### BMW/JAGUAR ZF5HP24 "A" CLUTCH DRUM FAILURE

Figure 1  
Automatic Transmission Service Group

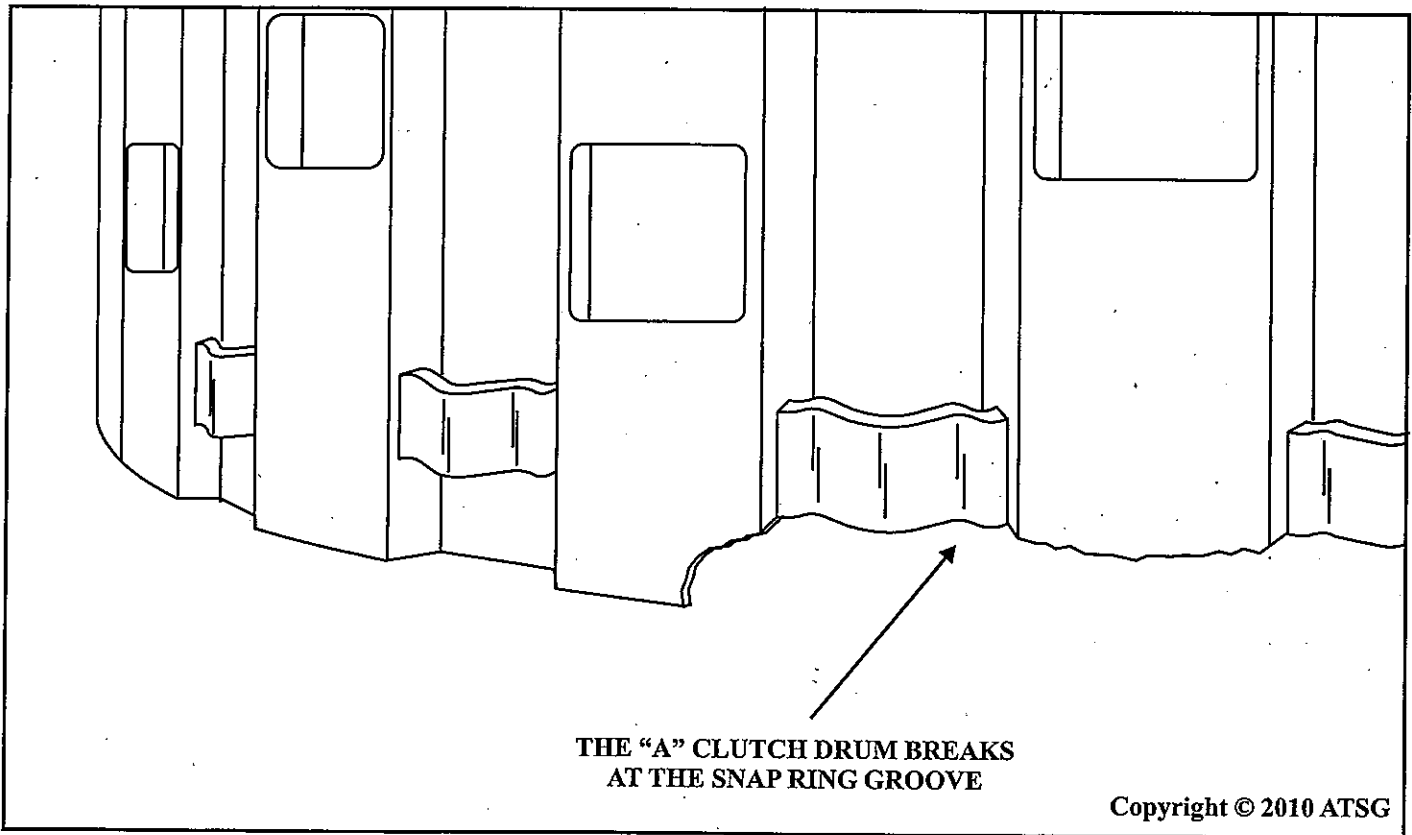
Upon disassembly of the transmission the "A" Clutch drum is found to be broken at the clutch pack retaining snap ring (Refer to Figure 1) and the snap ring has come out of the drum. The technician replaced the drum with the updated part only to have it come back with the same complaint and the same broken drum.

Figure 2

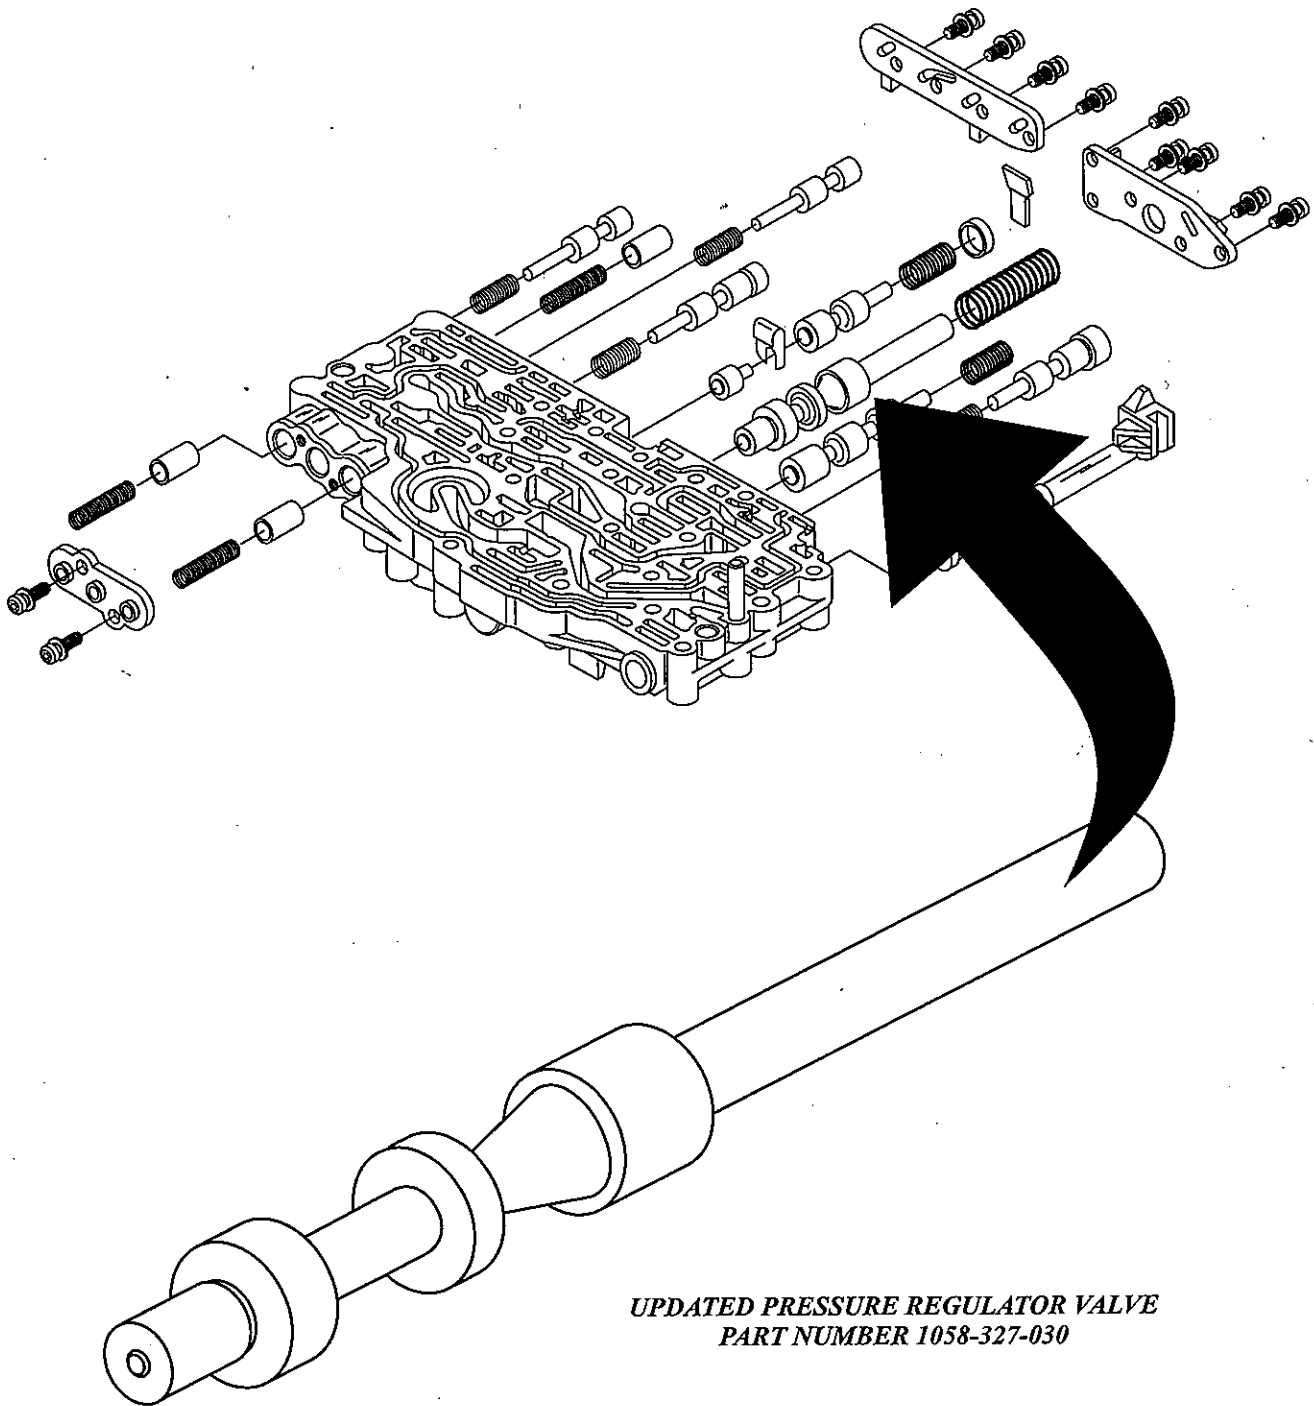
The drum is breaking in the snap ring area due to *un-commanded* pressure spikes. There is an updated pressure regulator valve (See Figure 2) which could help the situation as long as the valve bore is not worn. The pressure spikes can still occur and are caused by wear in the pressure regulator valve bore in the lower front valve body, Refer to Figure 3.

*UPDATED PRESSURE REGULATOR VALVE  
PART NUMBER 1058-327-030*

Using the part numbers found under Service Information, replace the pressure regulator valve and the lower front valve body.
